SITE PLAN
 SCALE 1" = 10'
 6175 SE 27TH STREET
 MERCER ISLAND, WA 98040
 PARCEL #2174503305
 ZONING: R-8.4

A NEW HOME AT:
 6175 SE 27TH STREET
 MERCER ISLAND, WA 98040

JOB NO: 23006
 DATE: 12/11/23
 DRWN. BY: TH
 REVISED: 8/20/24

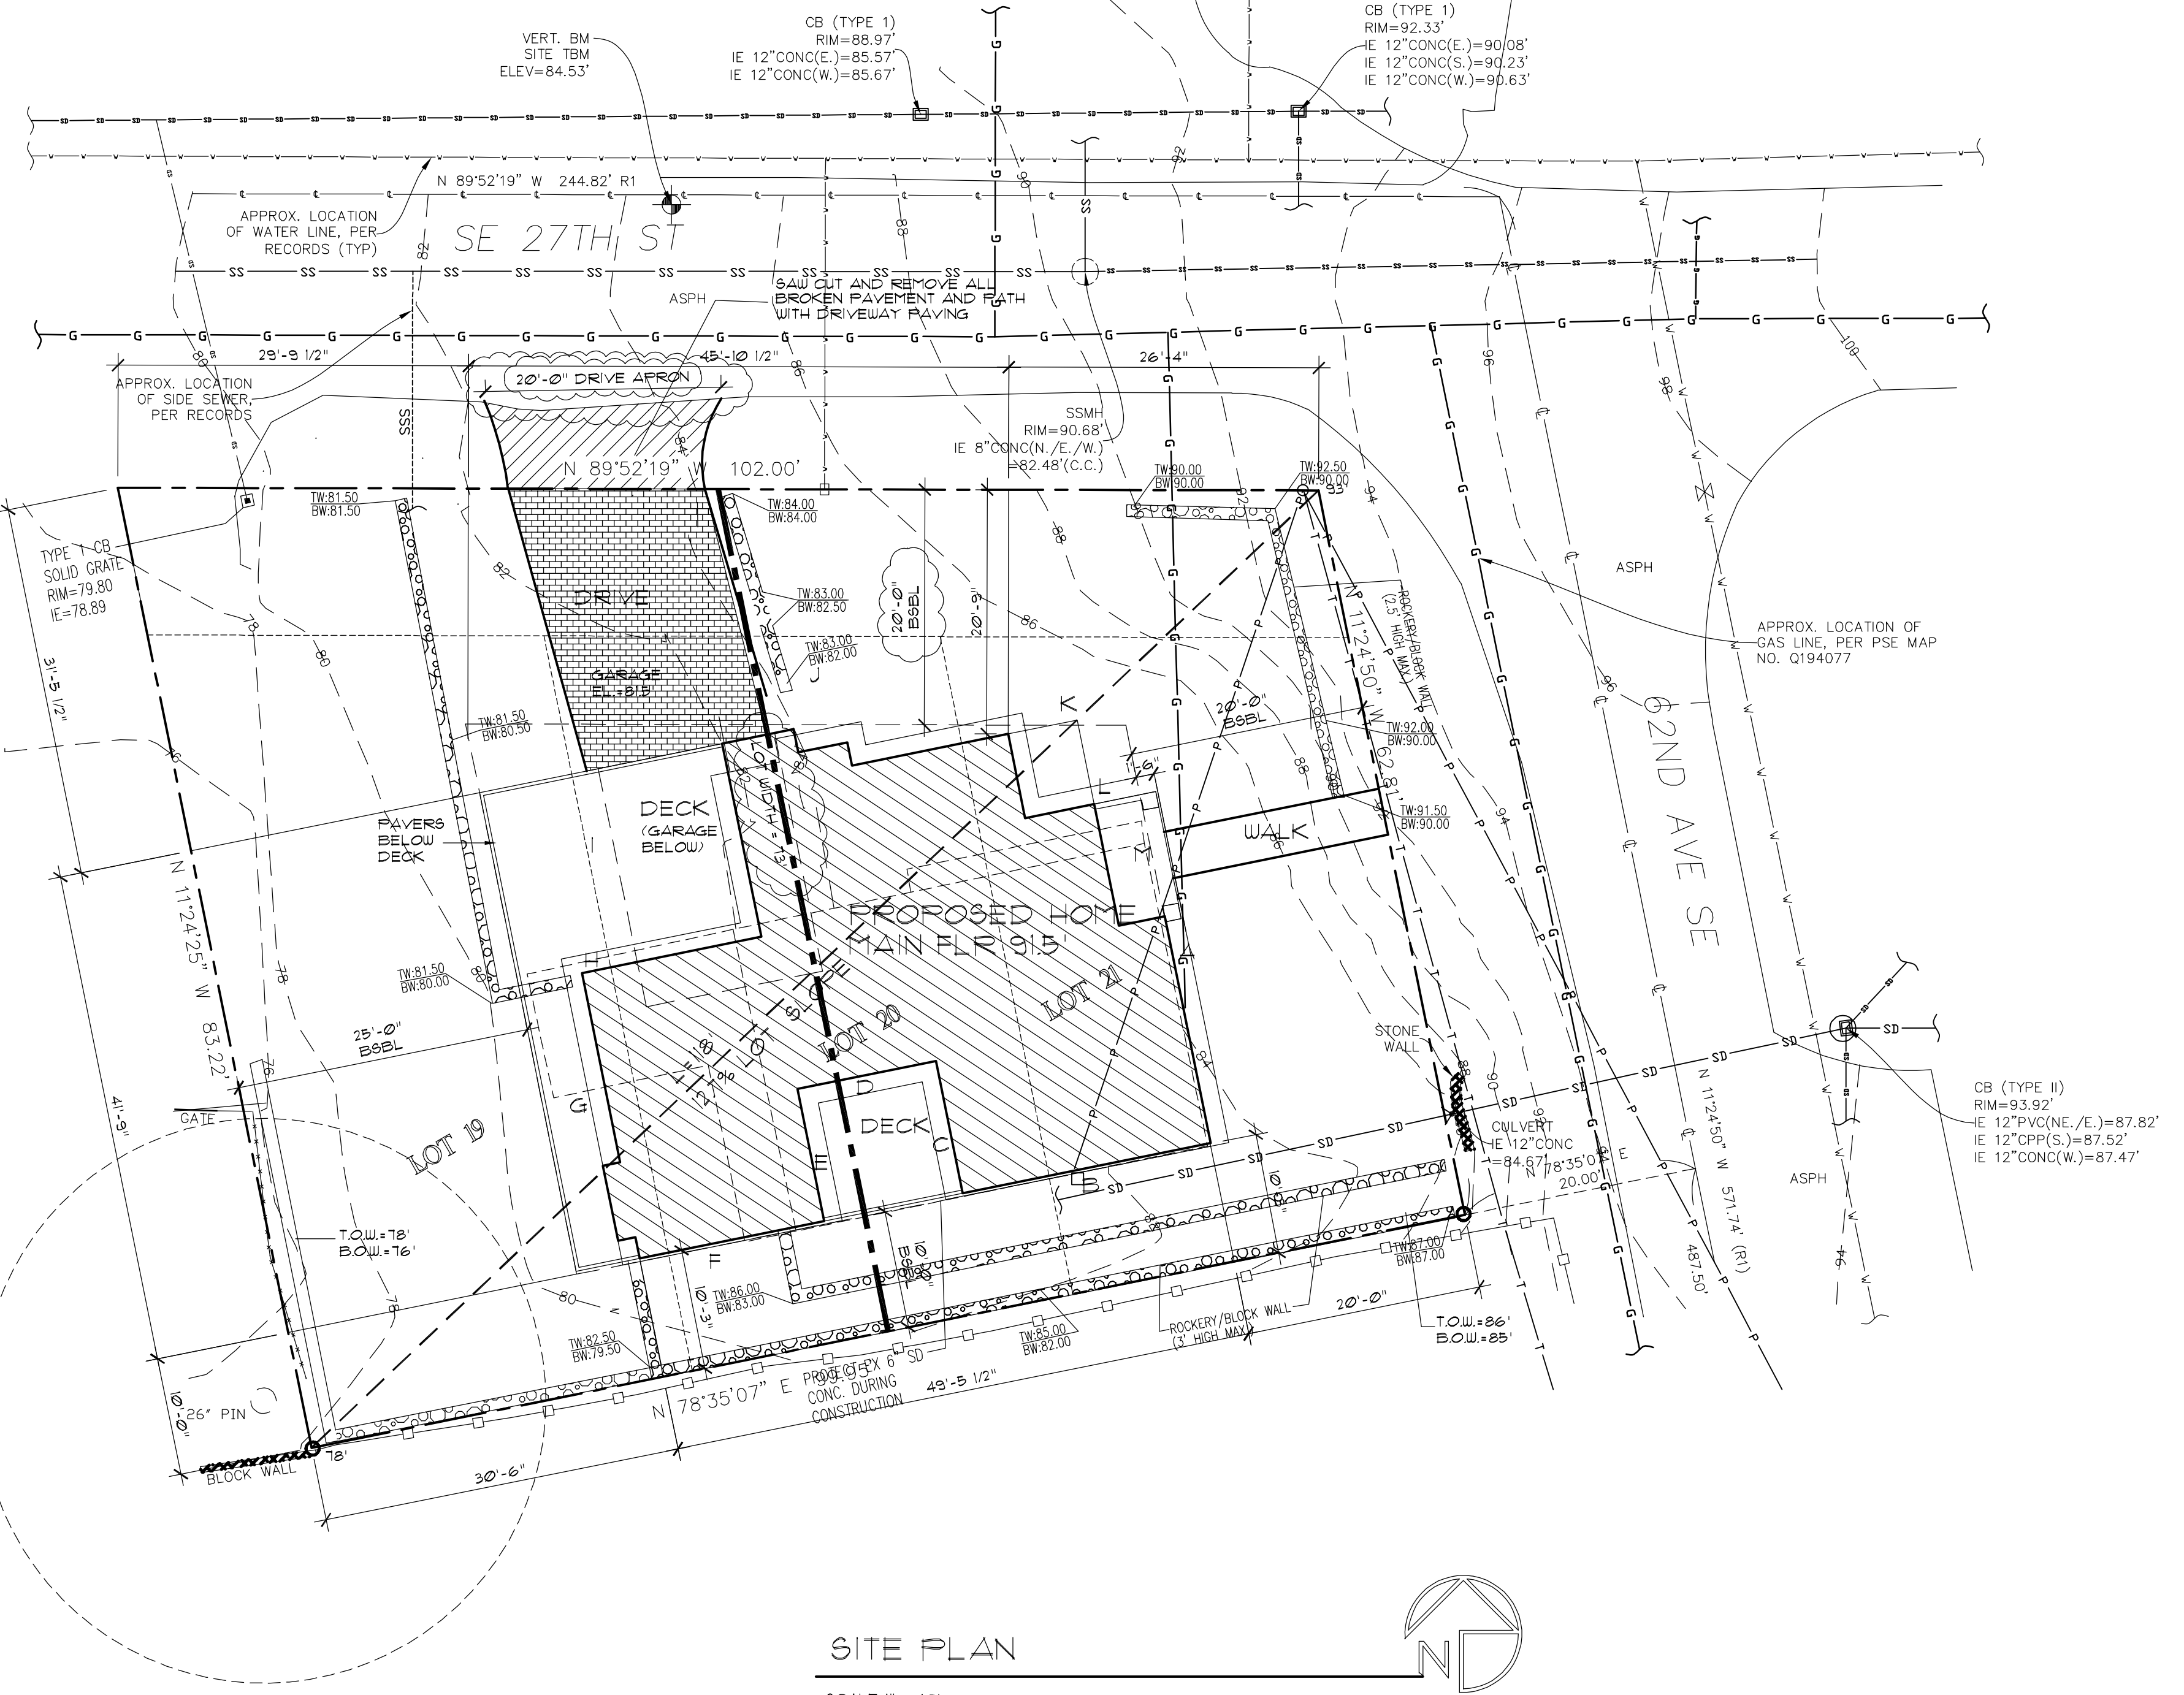
A NFPA 13D Fire Sprinkler System in compliance with NFPA 13D and CoMI standards shall be installed throughout the residence. A separate FIRE permit is required.

Note that this system requires a minimum of 1" water meter and 1" water supply line.

A NFPA 72- Chapter 29 Monitored Fire Alarm System in compliance with NFPA 72 and CoMI standards shall be installed throughout the residence. A separate FIRE permit is required."

MICC 19.02.020(F)(3)(d) requires noxious weeds to be removed during new development proposals. Please add a note to the plan set that states:

"Development proposals for a new single-family home shall remove Japanese knotweed (*Polygonum cuspidatum*) and Regulated Class A, Regulated Class B, and Regulated Class C weeds identified on the King County Noxious Weed list, as amended, from required landscaping areas established pursuant to subsection 19.02.020(F)(3)(a). New landscaping associated with new single-family home shall not incorporate any weeds identified on the King County Noxious Weed list, as amended, that removal shall not be required if the removal will result in increased slope instability or risk of landslide or erosion."

Pursuant to MICC 19.02.050(D) any "...rockeries, retaining walls, fences, or any combination thereof, are limited to a maximum height of 42 inches within that portion of any required yard which lies within 20 feet of any improved street." Please indicate the height of the rock wall that falls within 20 feet of the public-right-of-way.

If the height exceeds the 42-inch height limitation you can apply for a fence height deviation pursuant to MICC 19.02.050(F).

Fence height deviation required for 4' retaining walls.

This property is mapped on a lot with a hazard area. Per: 19.07.160(F.) (2) when excavation/foundation or other similar work will occur between October 1 and April 1 a wet season development waiver is to be applied and reviewed for work during the wet season. See this website for requirements, submission, and process:
<https://www.mercerisland.gov/cpd/page/wet-season-work-waiver-seasonal-development-limitation>
